UNITED STATES PATENT AND TRADEMARK OFFICE

APPLICATION NO.	FILING DATE	FIRST NAMED INVENTOR	ATTORNEY DOCKET NO.	CONFIRMATION NO.
09/710,539	11/09/2000	Benjamin N. Eldridge	276440-3	5812

# Office Action Summary

## DETAILED ACTION

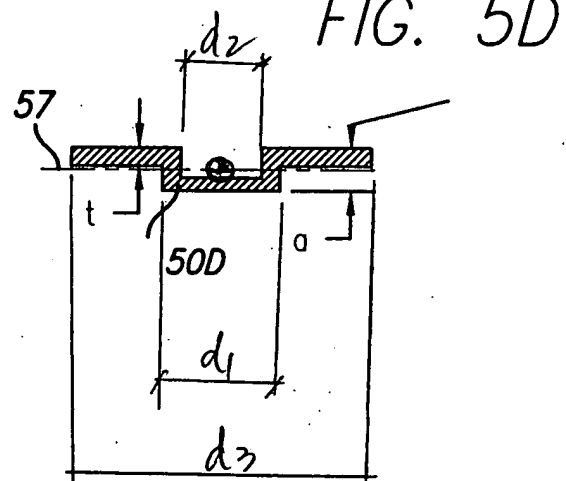
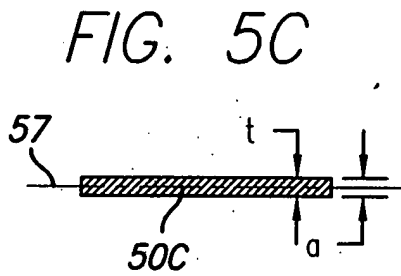
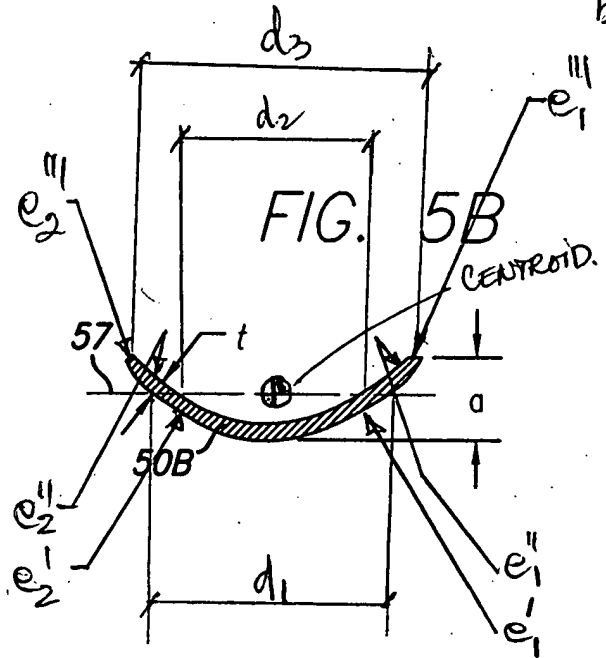
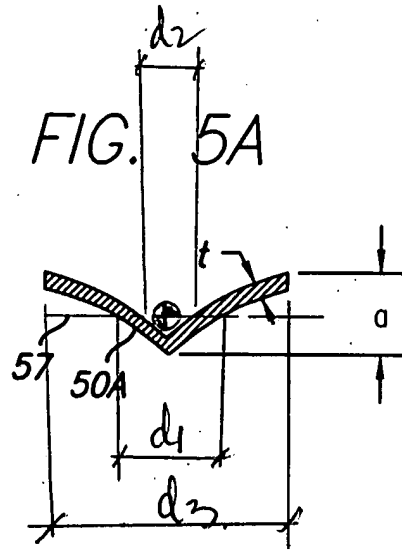
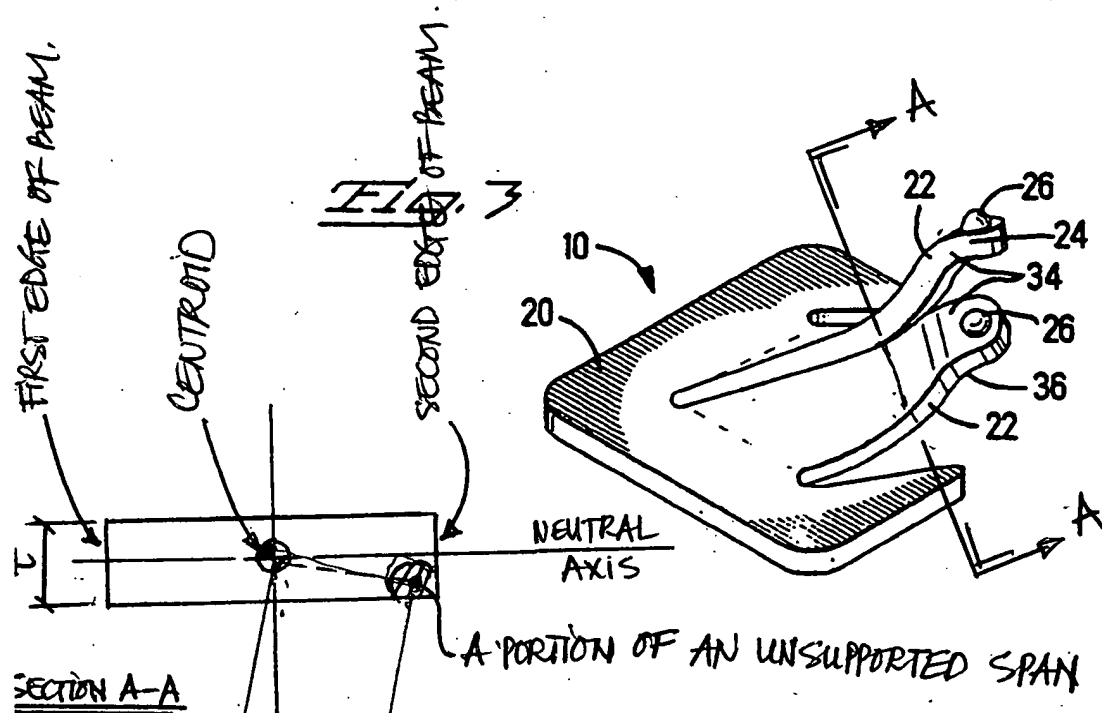
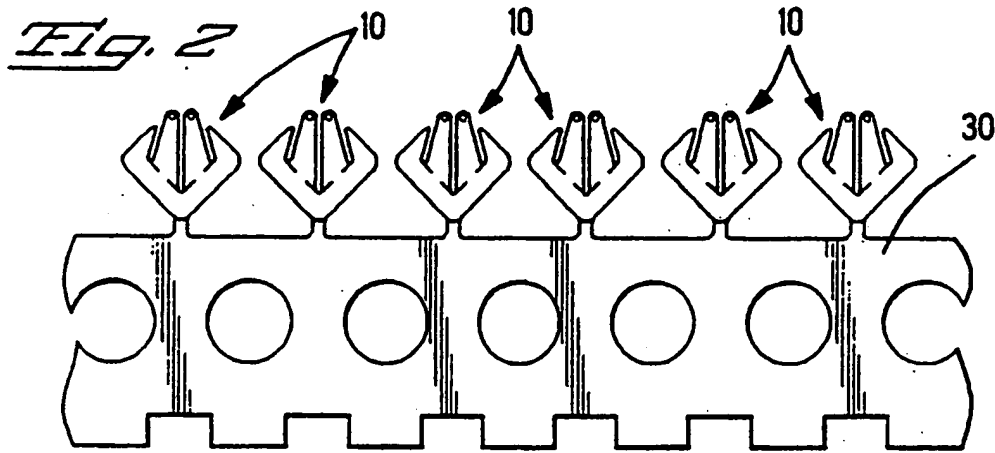
1) Grabbe et al. fails to discloses a spring contact having a beam "wherein said beam has a length running ... and a centroid of said every cross section" in page 6, lines 2-9. Examiner respectfully disagrees. Grabbe et al. discloses every element of claim 1 (see the rejection

described above and the analysis in the attachment). Grabbe et al. also discloses the newly claimed a distance extending from a neutral axis to a portion of an unsupported span of a beam is greater than one-half of a thickness of the beam (see attachment 2), as claimed.

$e_1$  = first edge  
 $e_2$  = second edge  
 $d_i$  = distance  
           between  
           edges.

ATTACHMENT 2

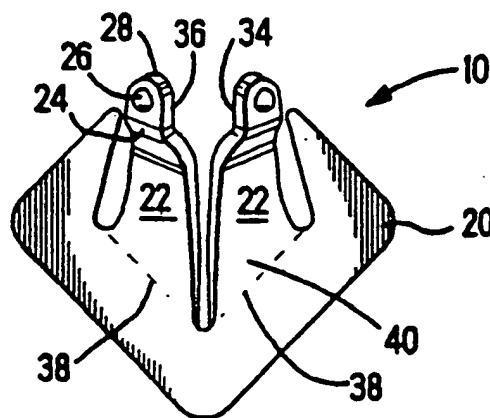
$t$  = UNIFORM THICKNESS.  
 $d$  = DISTANCE EXTENDS FROM  
 A NEUTRAL AXIS @ CENTROID  
 TO A PORTION OF AN  
 UNSUPPORTED *FIG. 4*  
 SPAN.

$$d > \frac{1}{2} t$$
